Subject: Pre-Application Summary Notes for Arco Iris Charter School at 8205 SW Creekside Place

# PRE-APPLICATION CONFERENCE MEETING SUMMARY NOTES

Prepared for  
**Arco Iris Charter School at 8205 SW Creekside Place**  
PA 2017-0045, August 9, 2017

## **Responses to Pre-Application Notes - PA 2017-0045, on August 9th, 2017**

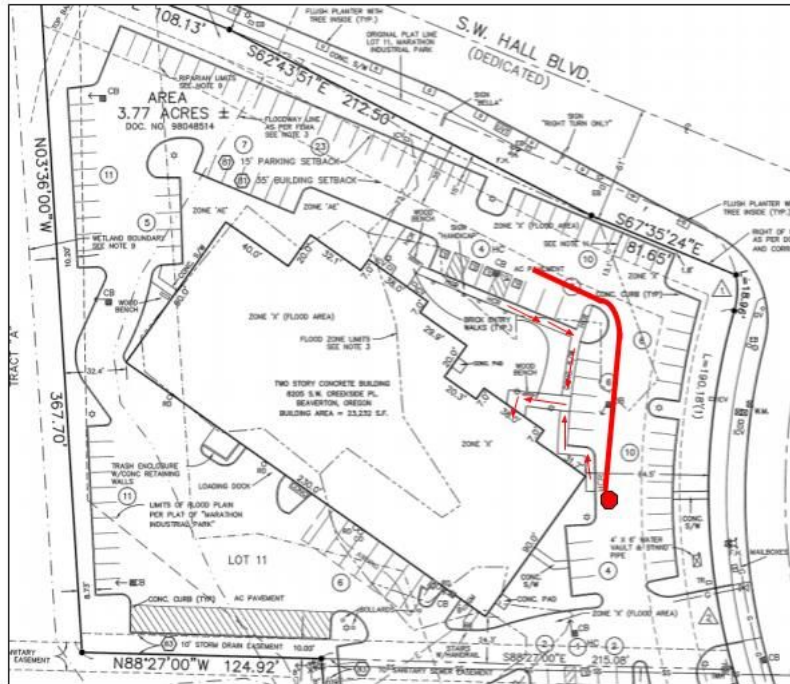
4. **Parking Analysis** Required parking is found in Section 60.30.10.5 of the Development Code. Minimum required parking for Middle and Elementary Schools is 1 space for every Full Time Employee (FTE). While compliance with minimum parking standards is important, the Planning Commission, per Section 60.30.10.7. of the Development Code, can find that more parking spaces for motor vehicle and bicycles may be required as a condition of Conditional Use approval. Accordingly, staff recommends that applicant prepare written analysis that identifies the on-site parking needs for the school (parking analysis). Parking analysis should account for all ancillary activities occurring on-site during day and evening hours. Parking analysis should not be limited to the minimum parking requirements of Section 60.30.10.5, but should adequately respond to the parking needs associated with all primary and ancillary activities anticipated to occur on-site. Parking analysis is to clarify if parking needs are based on actual enrollment or maximum school capacity. Parking analysis is to identify ancillary activities and time expected to occur during the days of the week.

5. Parent parking just after pickup: Many parents with flexible schedules like to stay at school immediately after pickup when the weather is nice to allow the kids to play with friends. These parents will park at the end of the school day rather than drive through pick up. Based on current numbers

and factoring in future growth we could have 30 to 40 vehicles parking for this.

**6. Provide peak hour on-site circulation plan - show parking availability.**

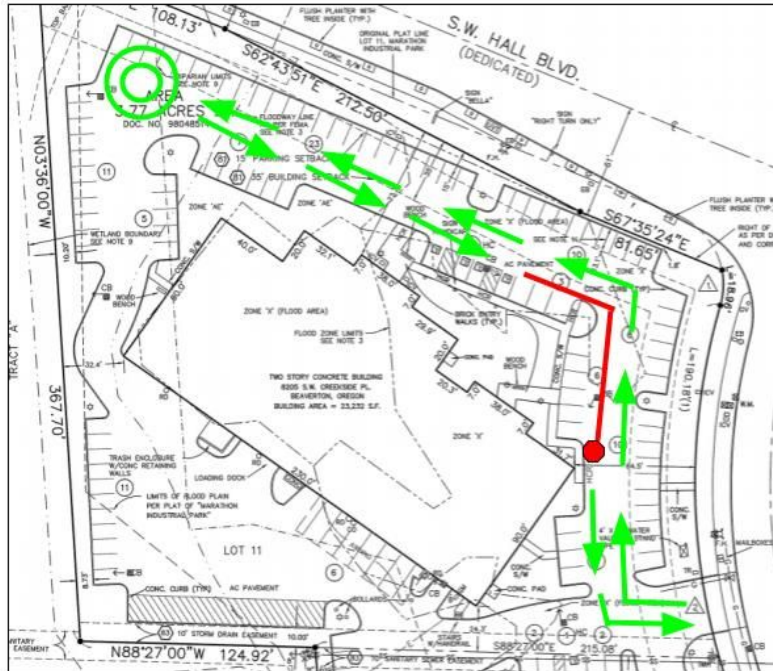
6. **Provide Peak Hour On-Site Circulation Plan – Show Parking Availability** See attached comments prepared by Ken Rencher, Transportation. The applicant will need to show that the proposed changes to the site will support safe and efficient circulation patterns for users of all travel modes. The application for Conditional Use also requires the applicant's written response to the Facilities Review approval criteria (Section 40.03 of the City Development Code). Interim use of play area for circulation around the building was discussed.

Traffic will enter the driveway off Creekside Place, pull in to the parking lot bypassing the main entry, turn around in striped turnaround that will be added farther into the parking lot, replacing 6 parking spaces, and return to the main entry sidewalk that faces Creekside Place. All cars stopped on the main entry side of Creekside Place will drop off the kids in their cars, move on, and allow the next group of cars to pull up and do the same. This stop-drop off area is indicated by the solid red line, which corresponds to the solid red line in the drawing for answer number 5. Staff will direct this process daily, and stop traffic if needed for access to ADA parking. The circulation pattern is indicated in the image below, along with photos of the pavement marking we would emulate, which is currently in use at Wilson High School in Portland, photo examples below. Available parking during this time will be just beyond the circular turnaround, and any available space along the drop off staging area.

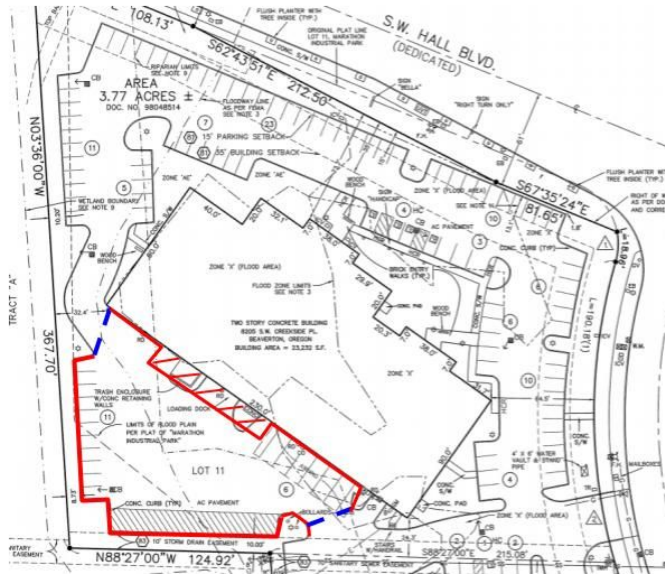
7. **Identify Outdoor Play Area** Conditional Use application site plan is to clearly identify all outdoor play areas (and improvements). The site plan is to show the boundary of the play area and is to show where fencing is proposed. If outdoor play area is not proposed, the narrative for Conditional Use should explain where and how recreation / recess is provided as part of the school program.

7. **Identify outdoor play area.** The play area is in the parking lot at the back of the building in a triangular area bordered by the building and the two curbs at the end of the asphalt area. See image below for outline of play area. The blue dashed lines indicate where vehicle access will be blocked off using cones or chains attached to bollards during normal school operating hours. The red bump out with hash marks at the back of the building indicate the approximate placement of a deck with railing that will bridge the opening of the loading door from our multi-use/gym area to the outside play area. The school anticipates eventually installing a permanently attached play structure toward the back corner of the triangular play area, leaving space for a drive lane available for fire truck access. At this time there is no room in the budget for a play structure and a fundraising effort will be started once school begins in this building, with a target of 18 to 24 months before being able to begin the play structure design and application process. No fencing is planned.
